CITY OF PORT LAVACA

SUBJECT: Animal Shelter renovations

Subject: B&R RFP-353-008 – Revision 1
Project Location: Port Lavaca Animal Control Center
Project Title: Renovations and Conversion of Kennel from Open Air to Enclosed Facility

Renovations and Additions to
Port Lavaca Animal Shelter
201 Stringham Port Lavaca, Texas 77979

FLOOR PLAN

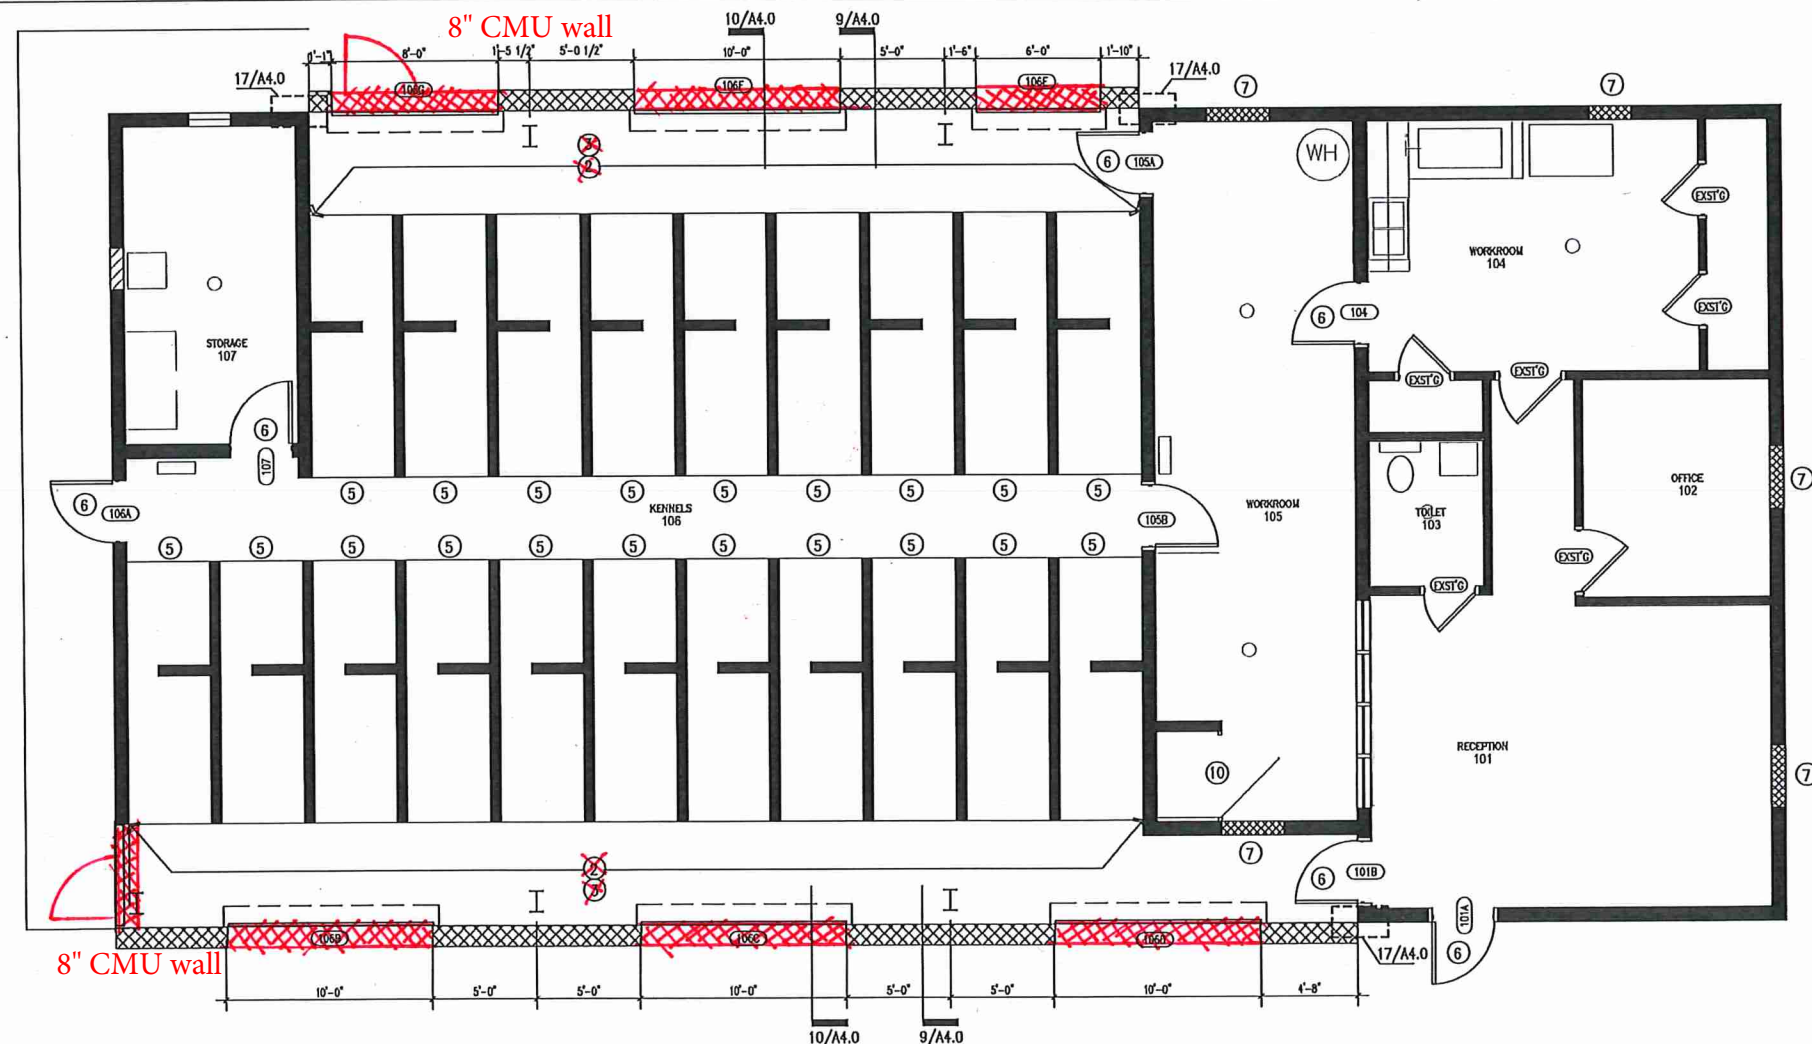
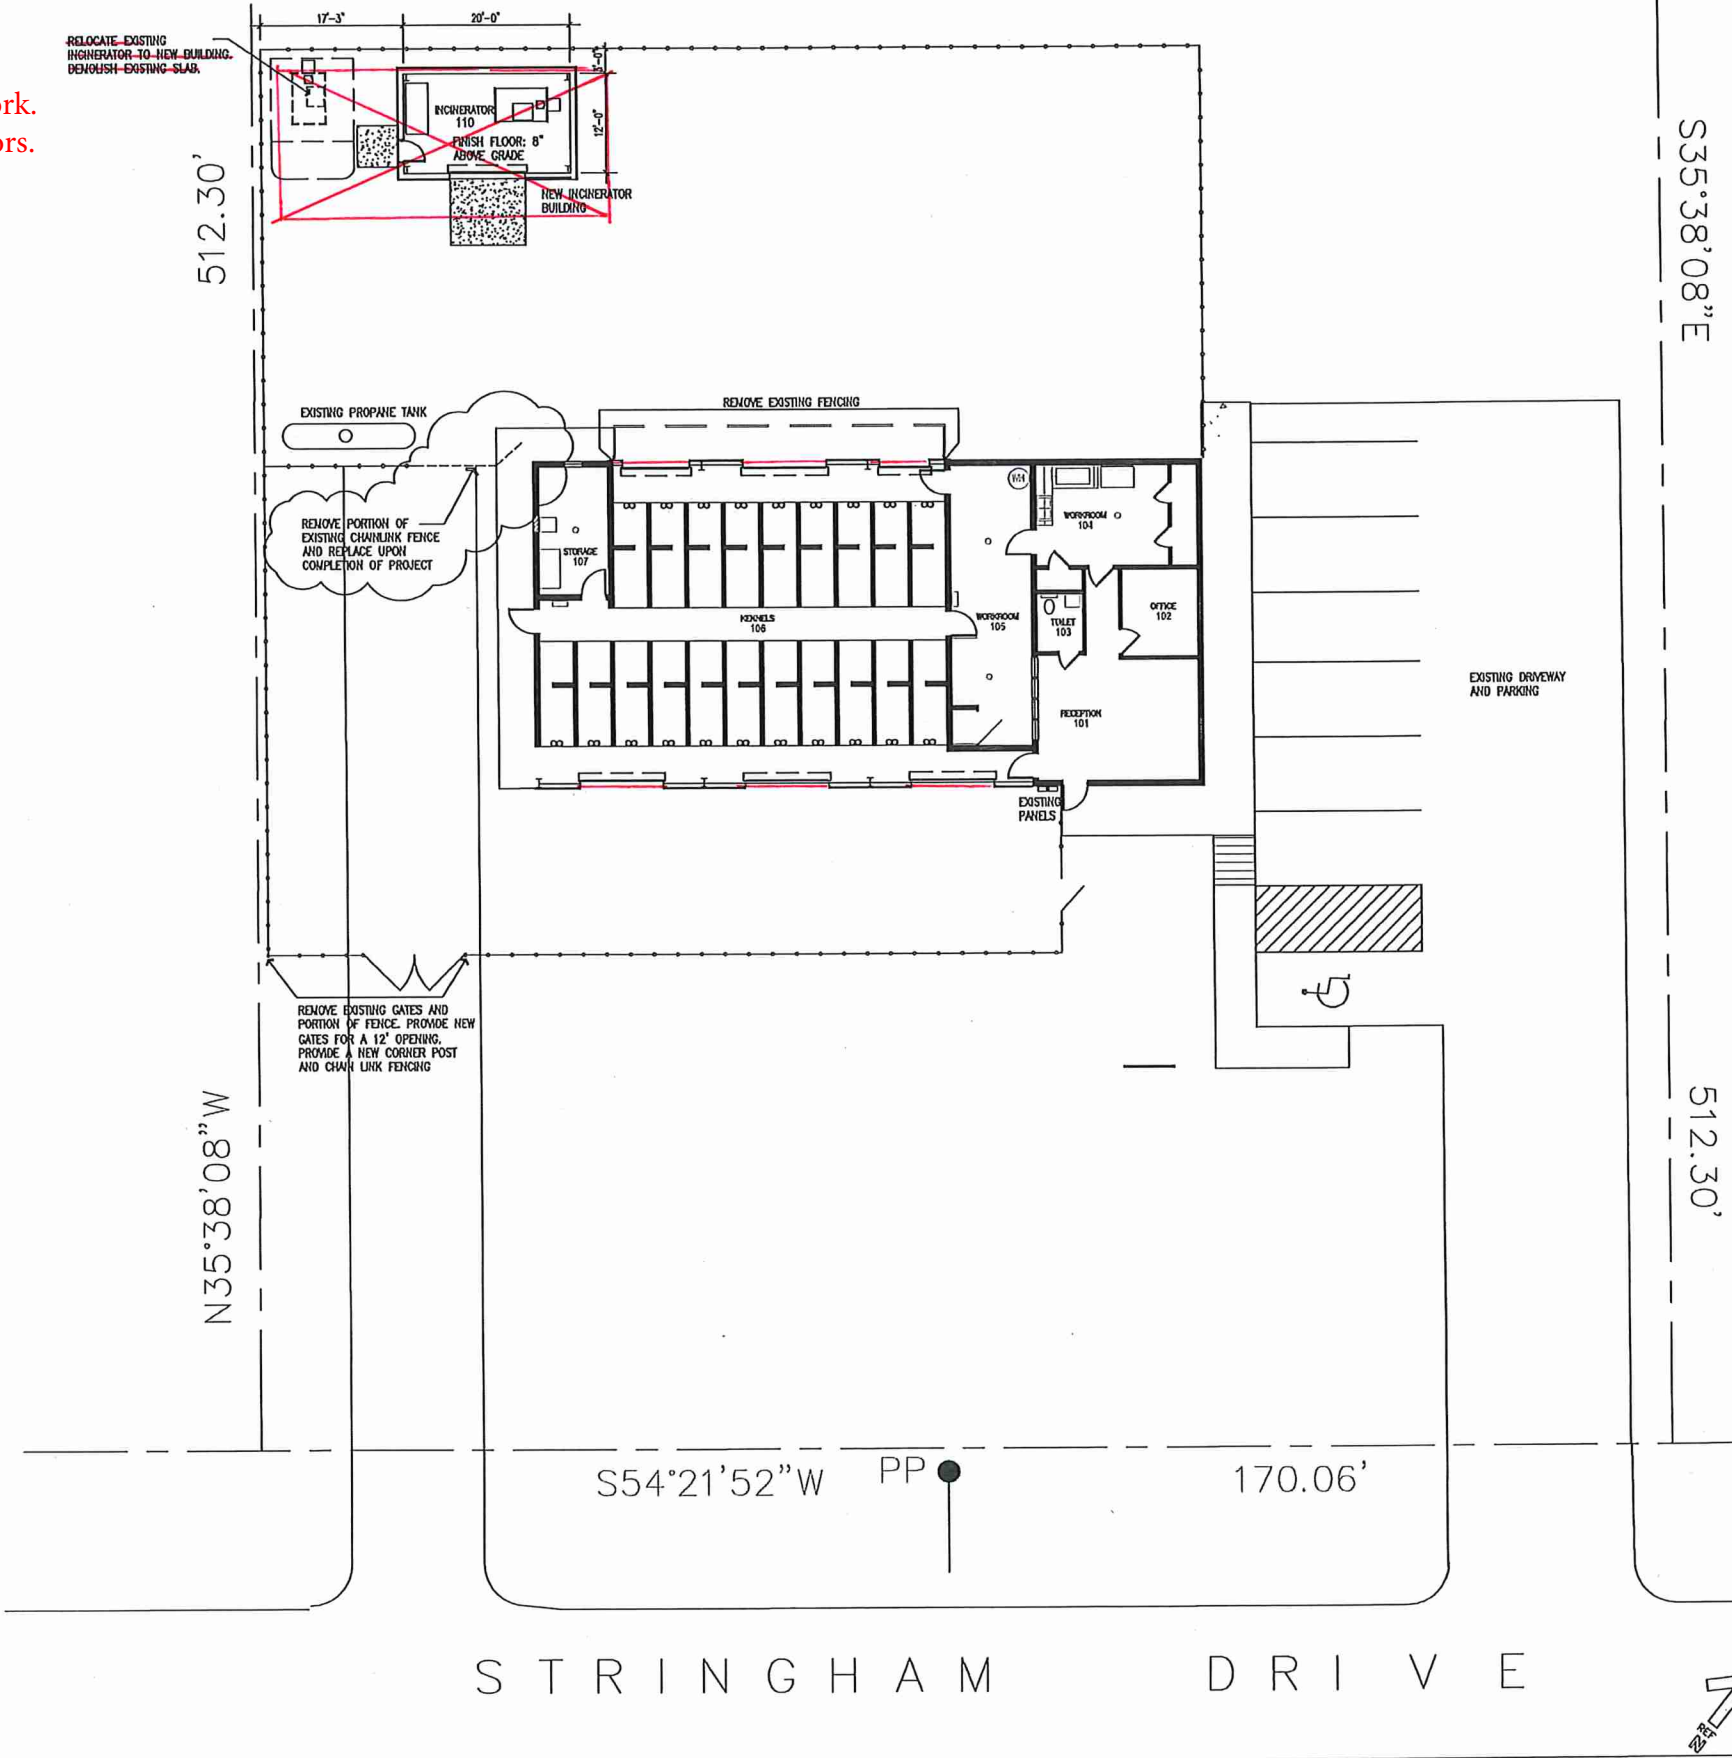
1. Delete the 6-OH doors in new wall and install 6-louvers instead for ventilation.
 2. Omit using wood framing and siding on small return wall on southwest corner and install 8" CMU block instead. Tie the block into the existing 8" CMU wall. Install a ped. door in this wall.
 3. install 1-ped door on new north CMU wall.
 4. Confirmed with Engineer that we can use 8" CMU instead of 12" since louvers are replacing the roll up ddoors..
- Note 1 edit - "install 1/4" screen on roof cvent.
- Note 2 - delete
- Note 3 - delete
- Note 9 -edit - install 6- new 8' LED lights and connect to existing light circuit.
- Remove clouding

A 1.0

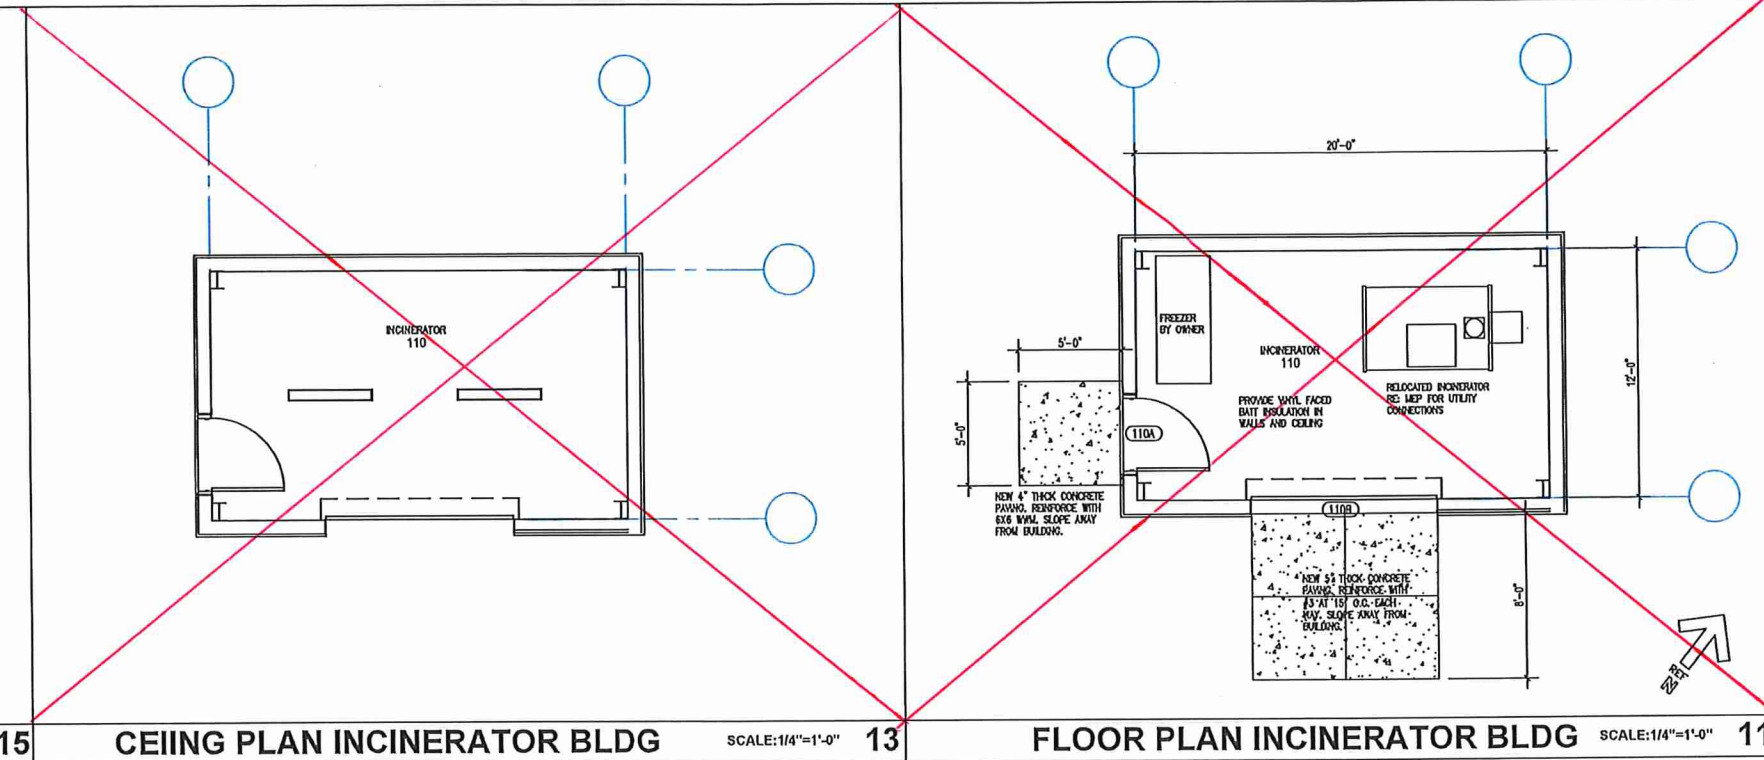
Delete incinerator building and associated work.
Reflect ne wall as solid wall with out OH doors.
reflect 2-ped doors and 6- louvers
Remove any clouding

FLOOR PLAN INCINERATOR BLDG

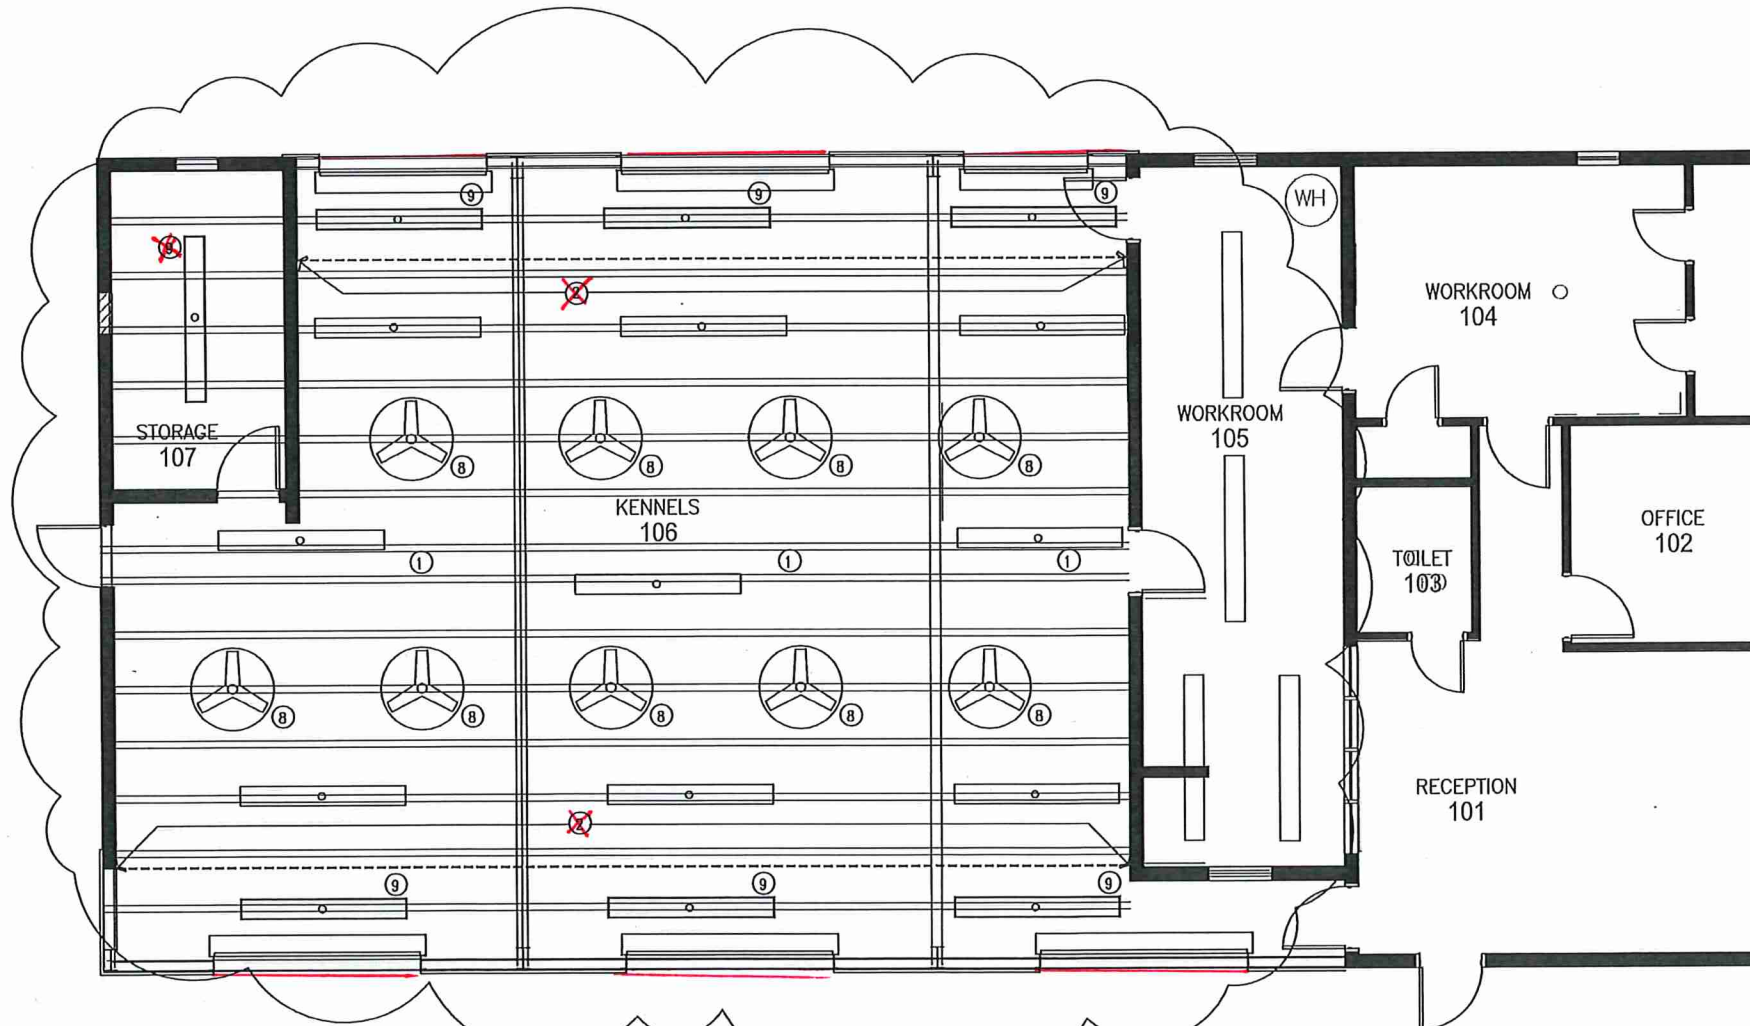
Delete incinerator building and associated work.
note 1 edit to read 1/4" wire mesh
remove note 9 in room 107
remove note 2 in room 106.
Note 2 - delete
Note 3 - delete
Note 4 - delete
note 9 - remove cloud and words Alternate #1
Show new wall as solid with out OH doors in
them, Show 2-ped doors and louvers.
Remove large cloud

ALTERNATE #1
WALL SECTION

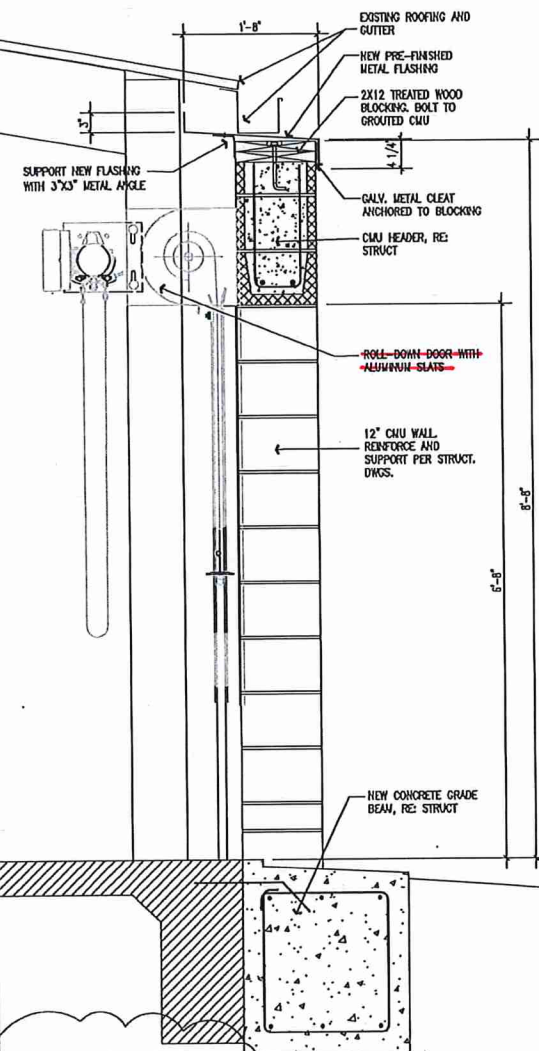
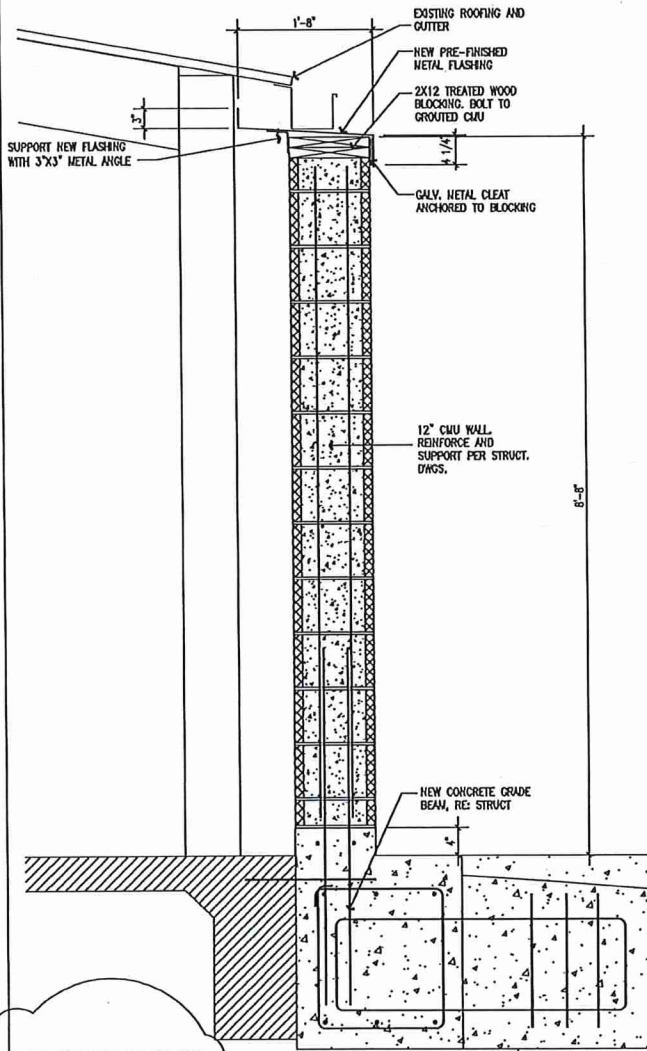
Remove OH doors and show louvers.
remove cloud

Remove cloud
